**Work Plan for a
Treatability Study in Support of the
Intrinsic Remediation (Natural Attenuation) Option at
Pumphouse 5 (Building 771)**

**Griffiss Air Force Base
Rome, New York**

Subject: Response to Comments on the "Intrinsic Remediation Treatability Study (TS) for Pumphouse 5", Griffiss AFB, New York.

FIGURE 2.11

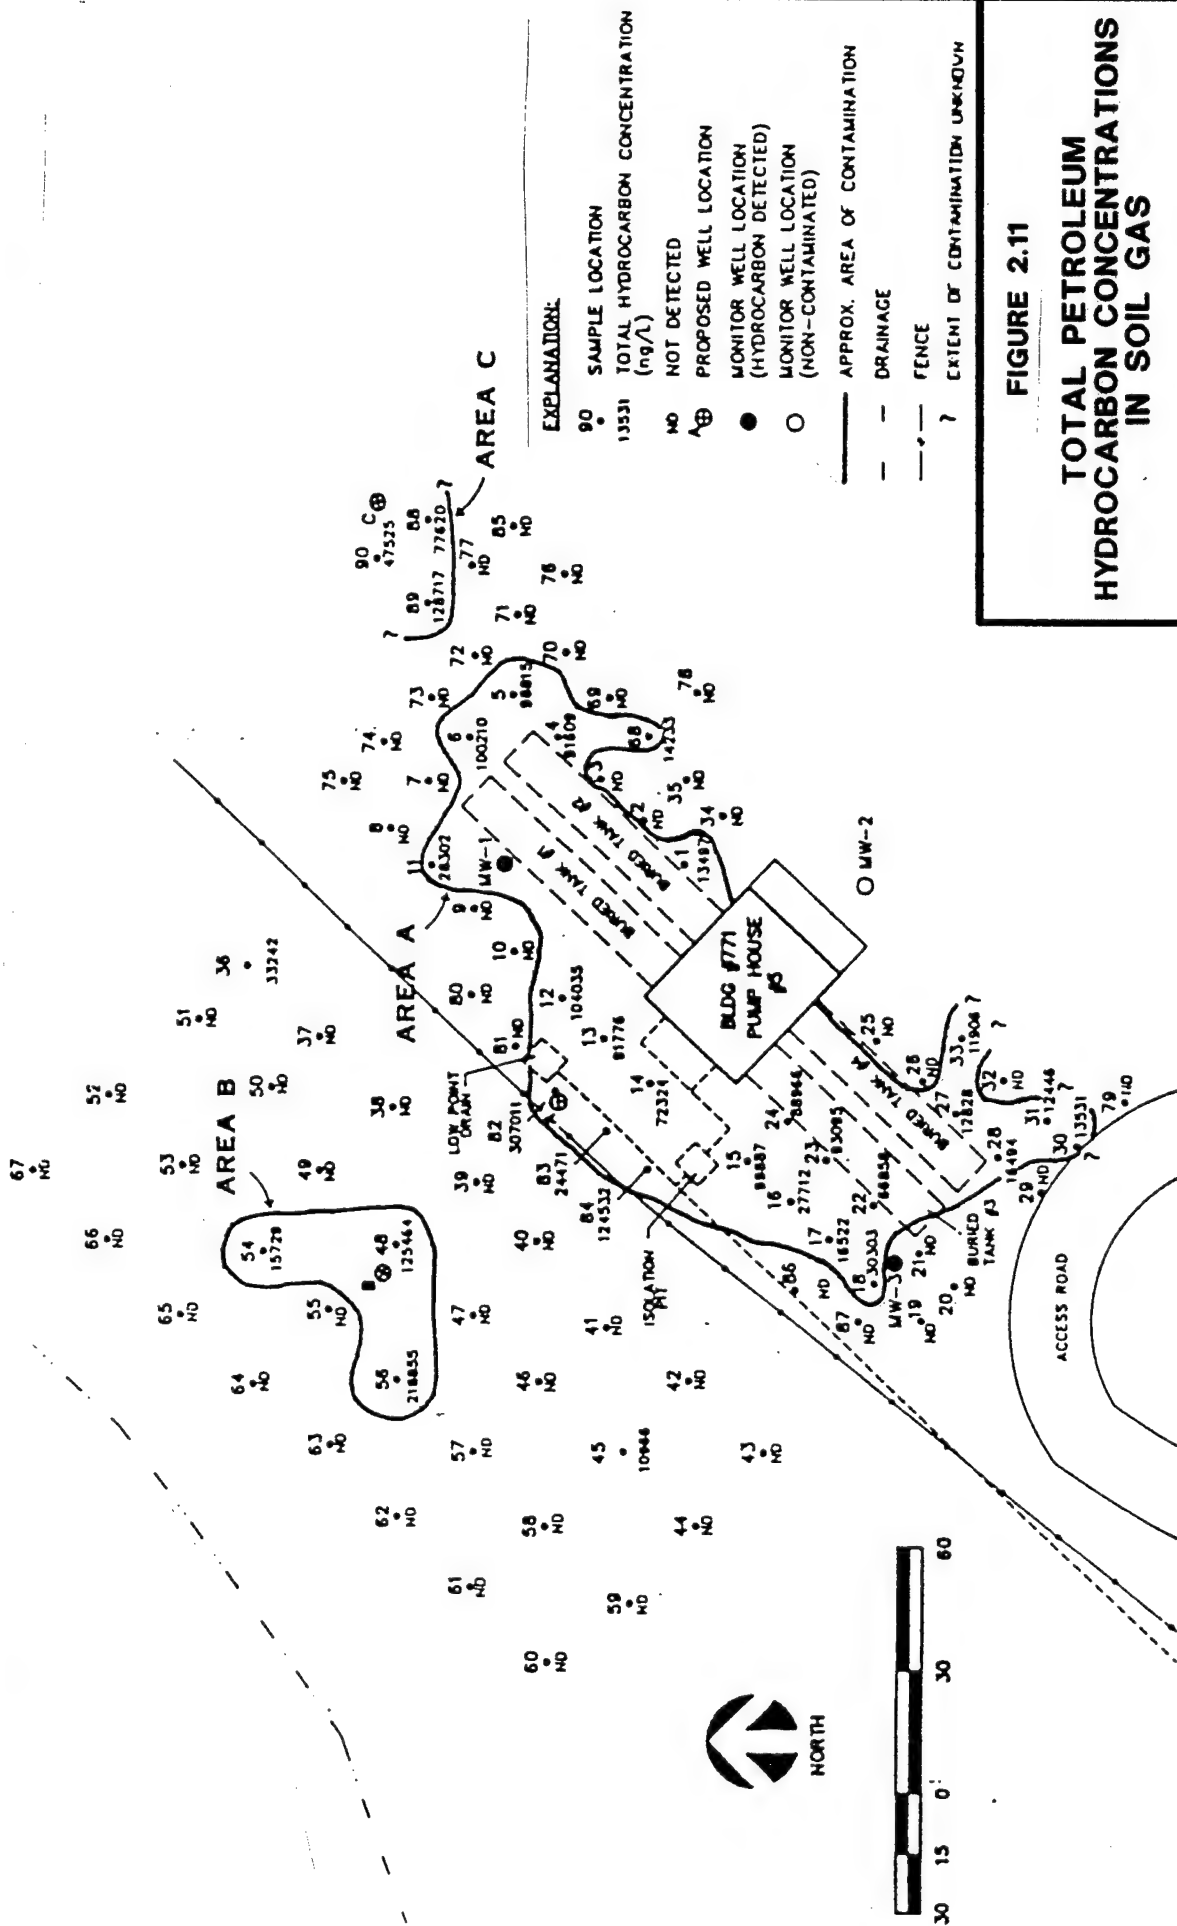
10. Page 2-25 (1st pp, last line): How do groundwater elevation diagrams define the extent of groundwater contamination? Perhaps the reference should be to Figure 2-10 or 2-11 and not Figure 2-9.

Response: As stated in Section 2.1.2.2 of the workplan, groundwater elevations are very erratic and flow in northern, western, and southern directions depending on location. Reference to soil gas results shown in Figure 2-10 and 2-11 are not necessarily indicative of LNAPL migration. Residual-phase hydrocarbons trapped in the vadose zone can also give positive results. Groundwater elevations will be remeasured in the June 1995 field work. Please see comment 8 from the NYDEC.

FIGURE 3.3

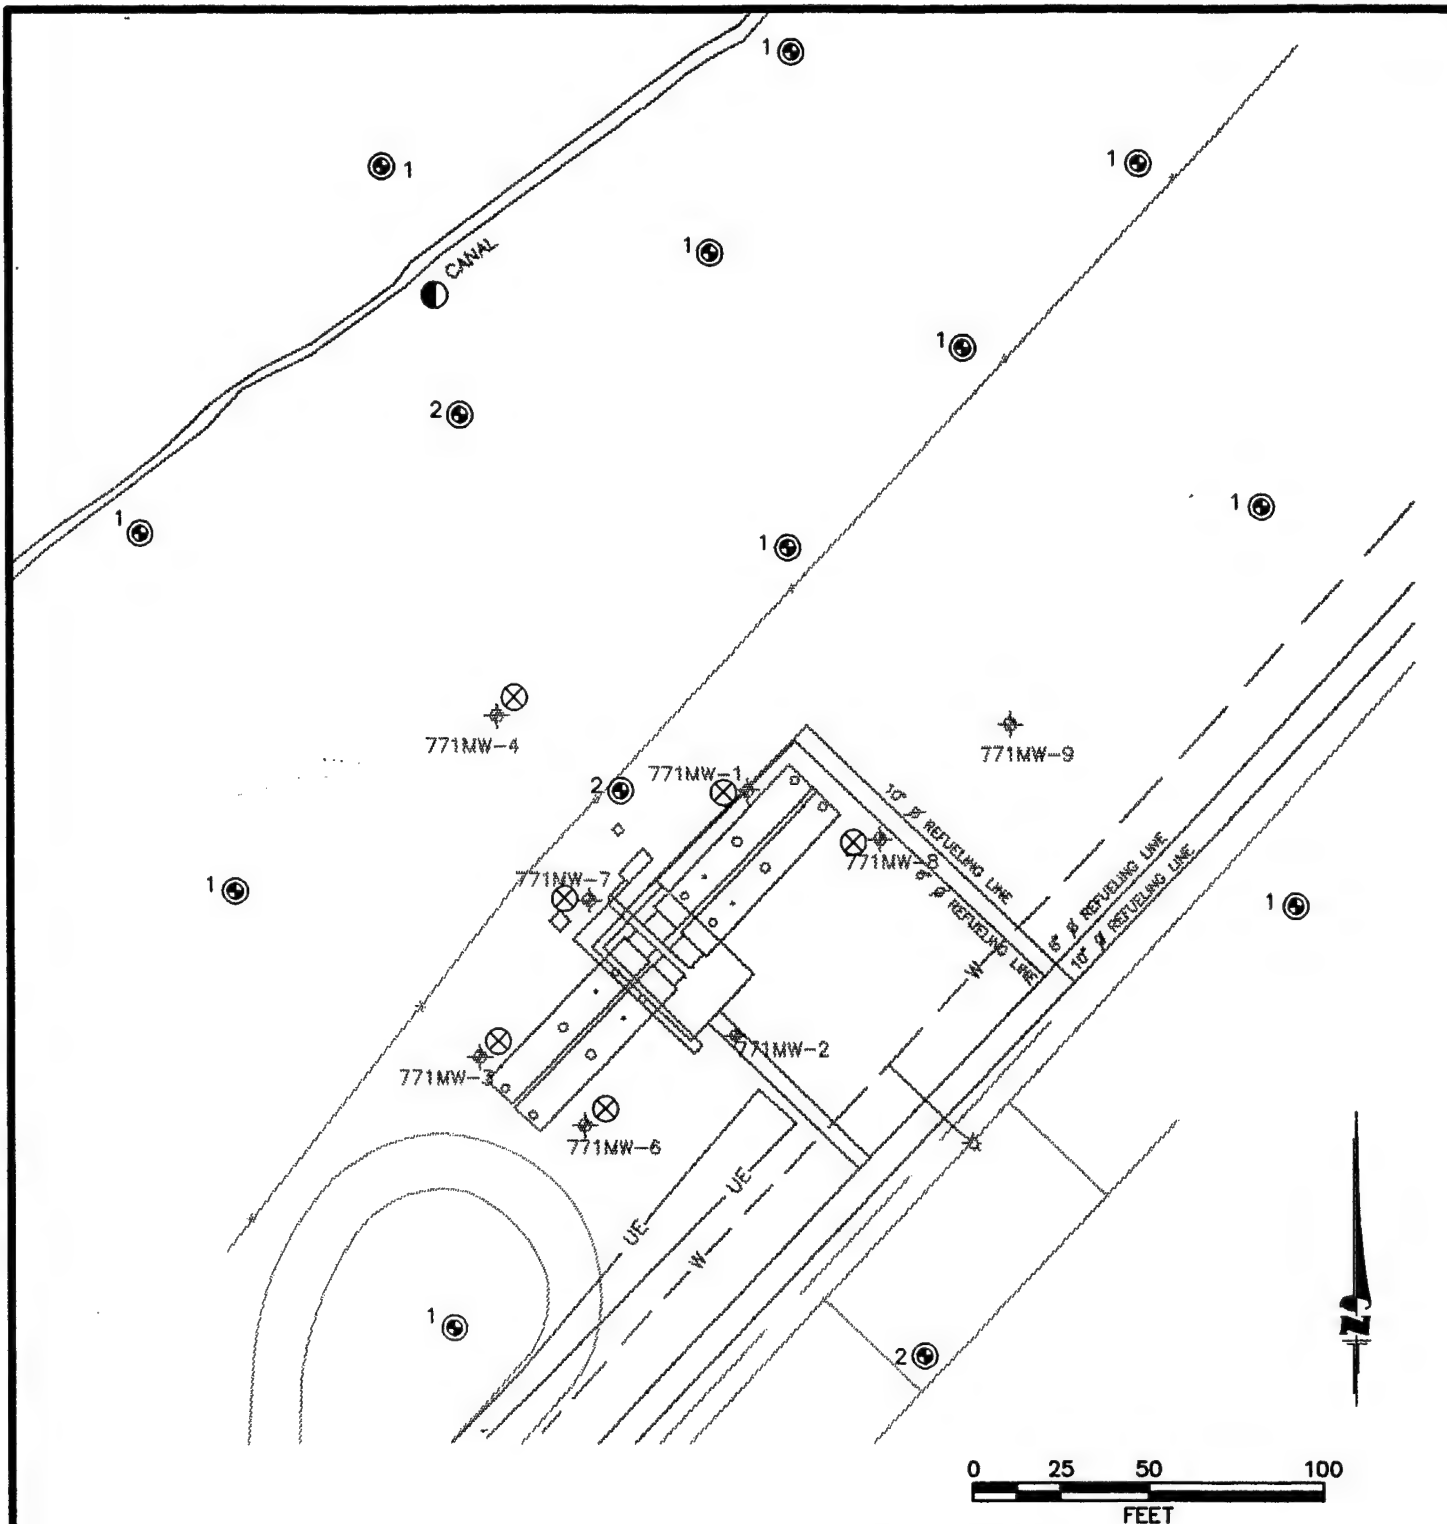
15. Sections 3.2.2.3.1 and 3.2.2.3.2: These sections discuss deep and shallow monitoring points, however, it is unclear from Figure 3.3 which are to be used and where. Please explain. Also, are well screens meant to straddle the water table?

16. Figure 3.3: I would like to see an additional sample point placed immediately north-northwest of monitoring well 771-MW4 (in between the two locations already depicted and in a direct line with the sample on the far side of Rainbow Creek).

Response: Figure 3.3 will be clarified to show the location of proposed deep and shallow monitoring points. Shallow monitoring points will be screened across the water table, while deep screen will be placed 8 to 10 feet below the water table.

Response: Additional sampling locations have been added to Figure 3.3 to satisfy your request for additional sampling points and to maintain a sampling line toward the creek.
